A/TM-LTYT/478

A/TM-LTY/478 回應運輸署的擬問

TPB / A / TM-LTYT / 478 車輛流量評估

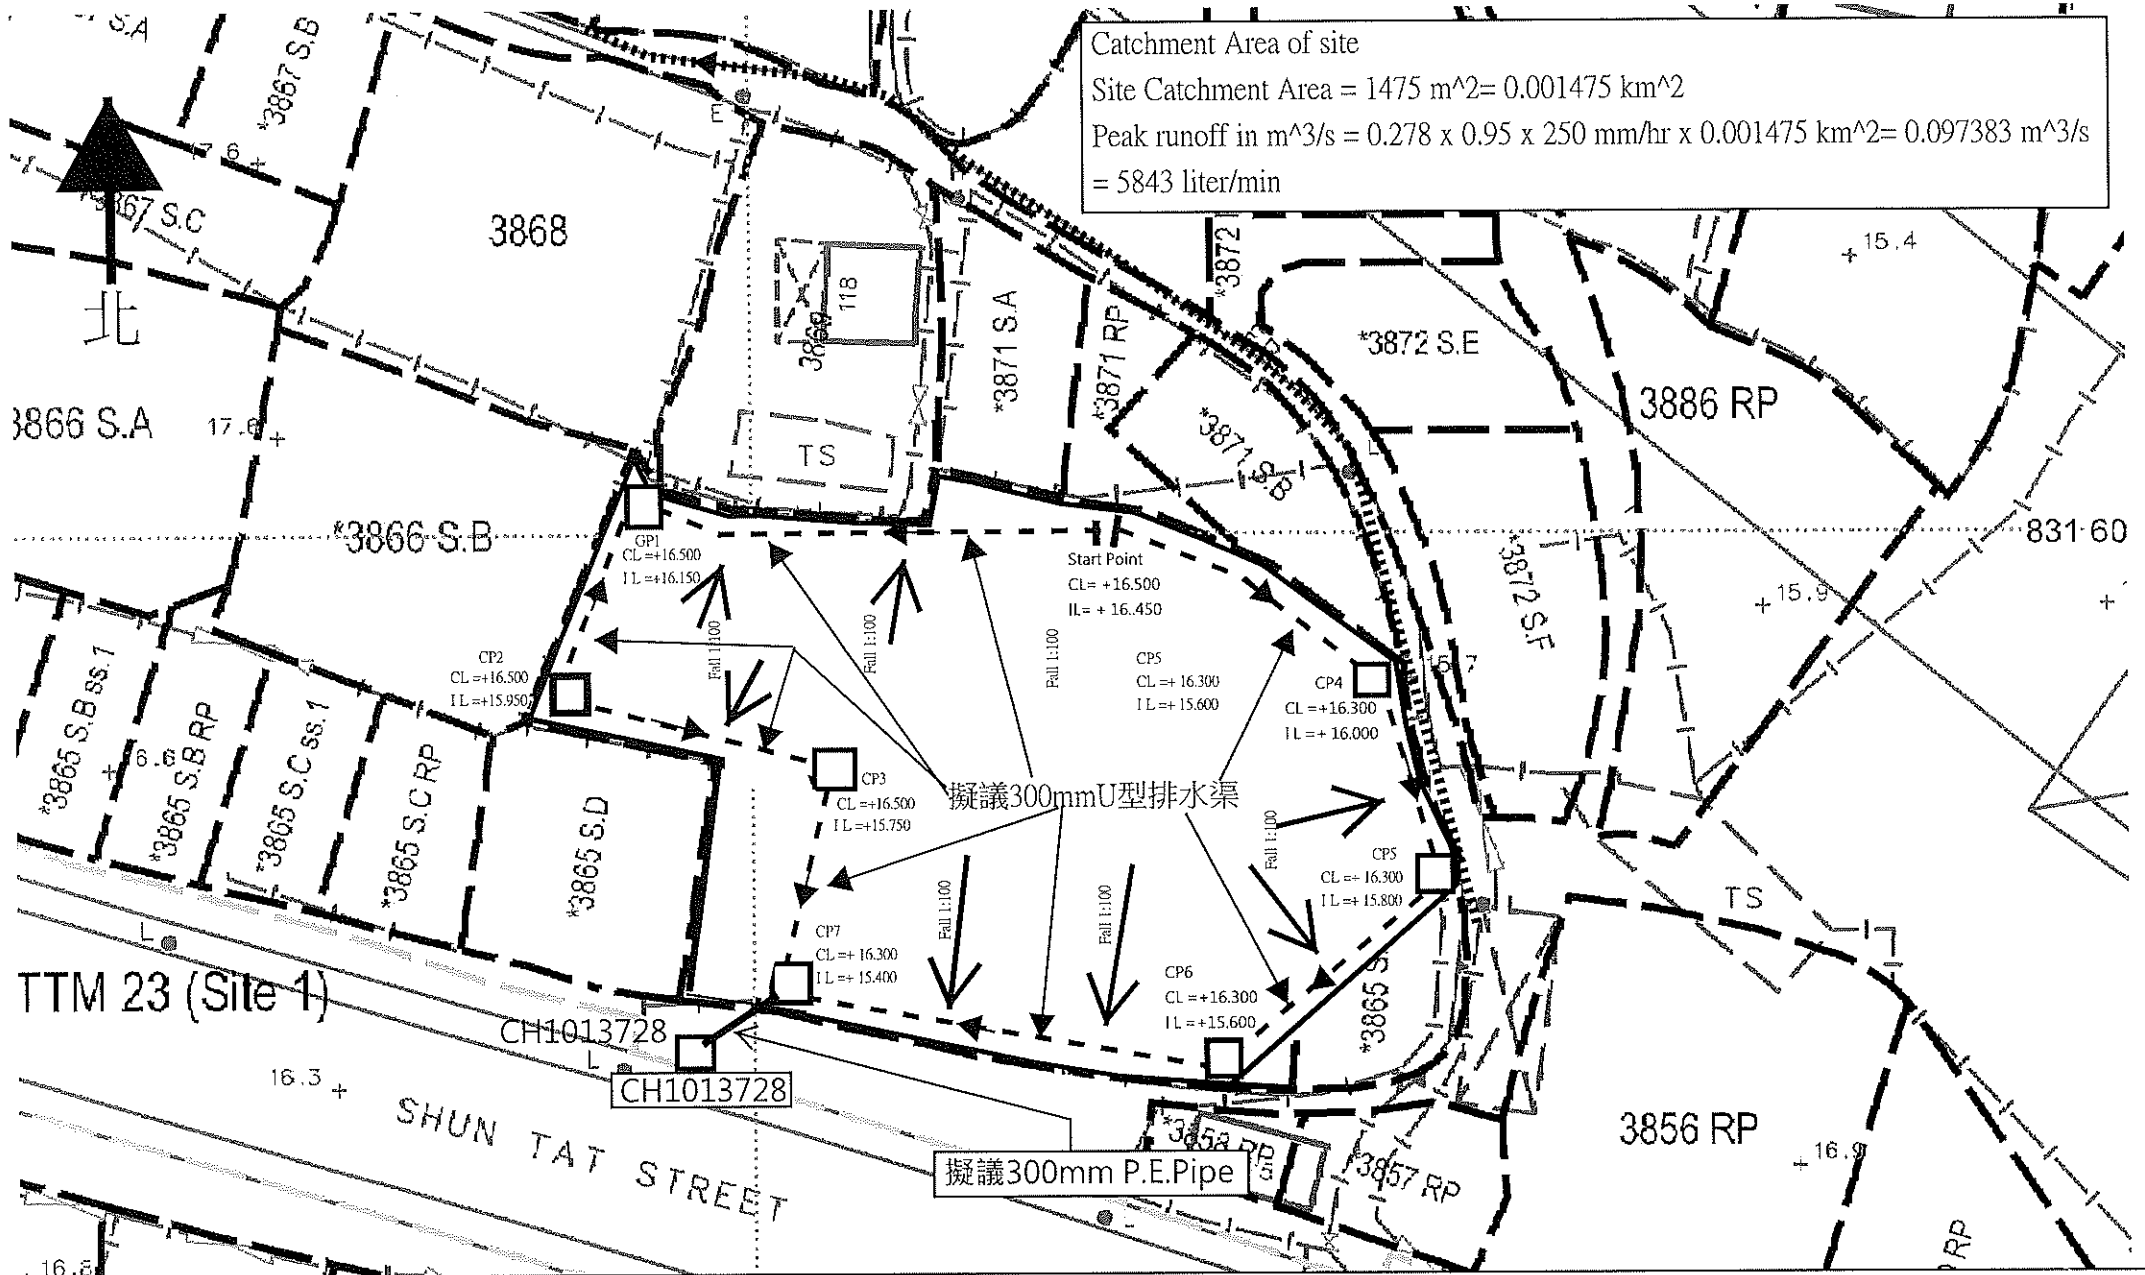
- i. The proposed u-channel should be installed at the parameter of the site to receive the catchment of the site, or the applicant can show the runoff outside the channel at the south-western side falling to the proposed u channel.

- ii. The existing drainage system to which the proposed drainage connection is to be made is not maintained by this Department, consent from the concerned parties/owners should be obtained for the proposed connections to their drainage system.

我等決定將U型渠道收集的雨水排放至西南方的政府集水井 (CH1013728)

我等決定將U型渠道收集的雨水排放至西南方的政府集水井 (CH1013728)之前的建議在此撤回

鄰近渠道說明

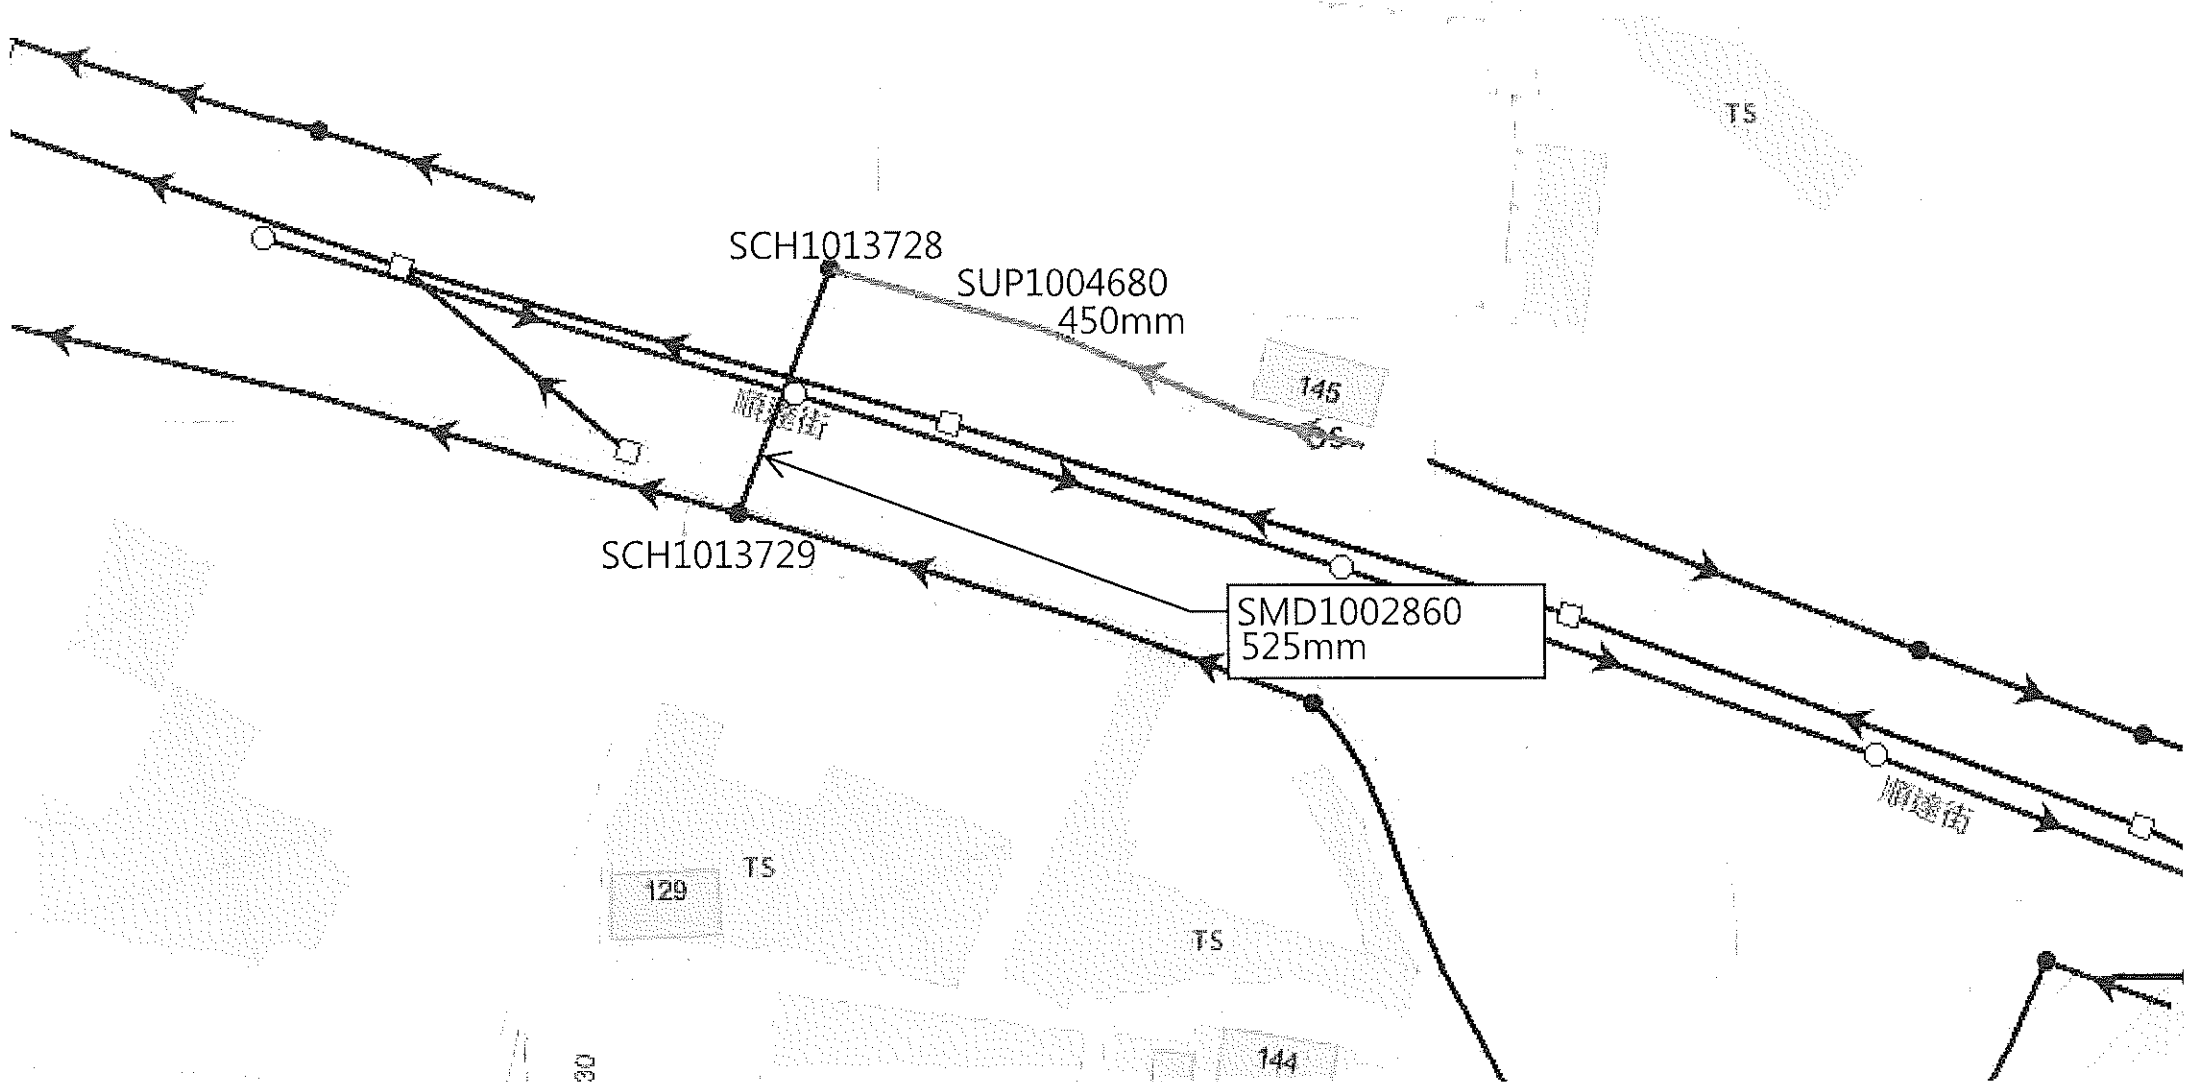
2. The existing u-channel proposed to be connected is not DSD's facilities according to our drainage record plan. DSD noticed that the proposed drainage connections to the downstream areas will run through other private lots. The applicant shall demonstrate that the proposed drainage construction works and the operation of the drainage can be practicably implemented on site. The applicant shall also check and ensure that the proposed drainage works and their downstream drainage systems have the adequate capacity and are in good conditions to accommodate the surface runoff collected from the application site and its upstream catchments. We have the following comments/observations on the captioned submission: -

有關早前的排水建議因並不完善，我等決定撤回，現附上全新的排水建議希望能得到貴署認同。

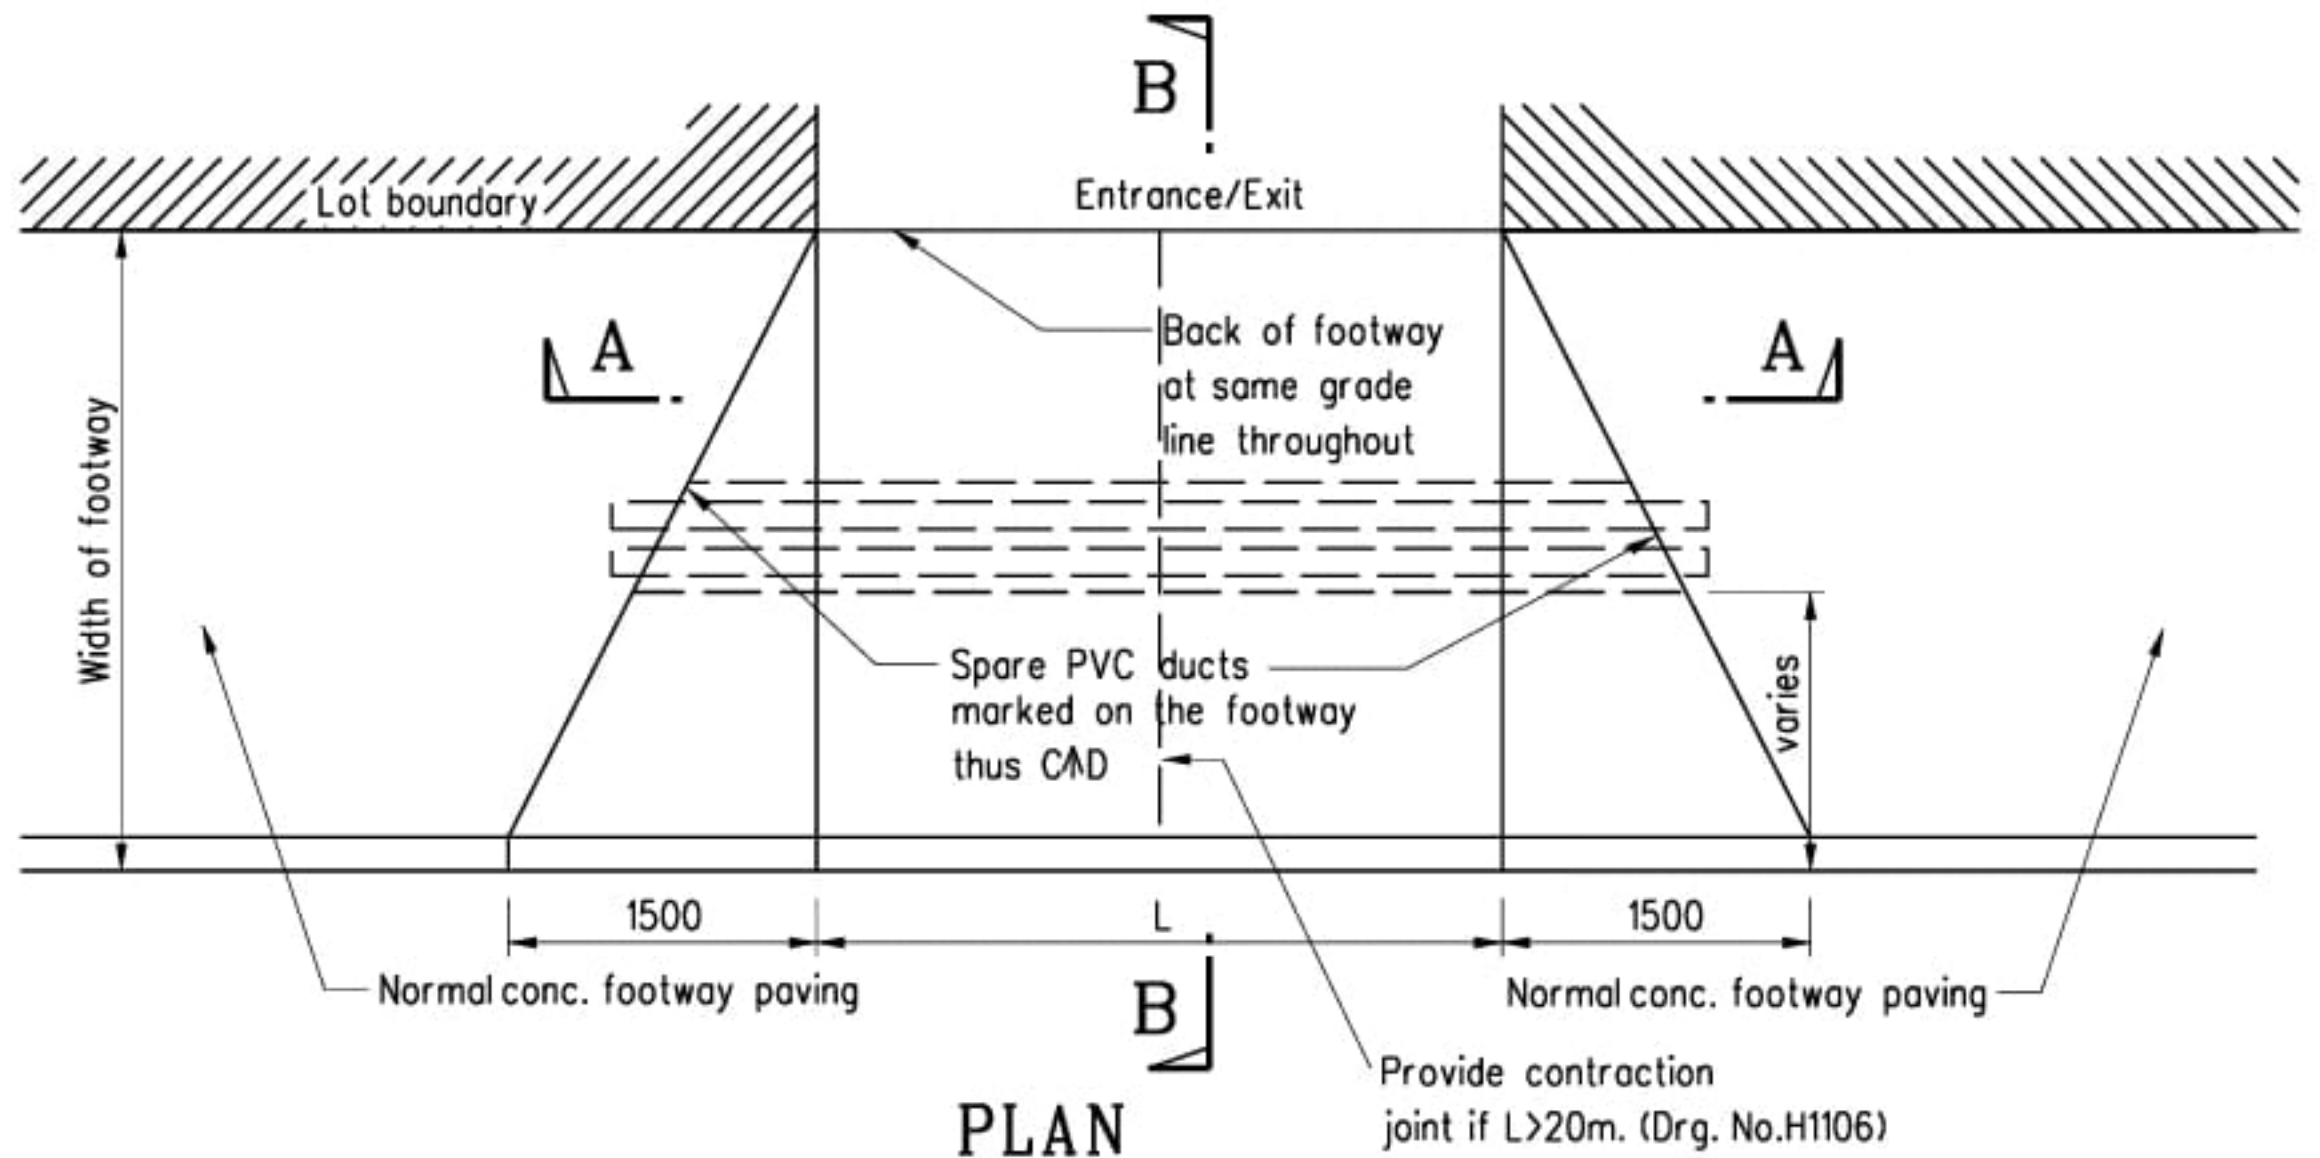
- b. Sufficient vehicle manoeuvring space should be reserved in the open area of the proposed site. Please ensure that no queuing and / or waiting of motor vehicles from the site onto Shun Tat Street would occur and no motor vehicles shall be permitted to reverse into and out of the site onto Shun Tat Street.

- c. It is noted that a 8m wide vehicular access is proposed. Please supplement the swept paths showing the light goods vehicles (LGVs) and medium goods vehicles (MGVs) (i) entering the site from and leaving the site to Shun Tat Street via the private lot and the unallocated and unleased government land as stated in (a) above; (ii) manoeuvring within the open area of the site; and (iii) entering and leaving the LGV and MGW parking spaces. In particular, please clarify that LGVs and MGVs will not reverse out of the vehicular access of the site from the parking spaces as inferred from the layout plan.

經過計算早前的停車位布局圖有部份輕型貨車車位須要改動，以方便中型貨車掉頭，連同此函附上新的布局圖給與貴署審議。

A,B,C,D為中型貨車進入場內停泊模擬路線
 1至8為中型貨車由車位離開至順達街模擬情況
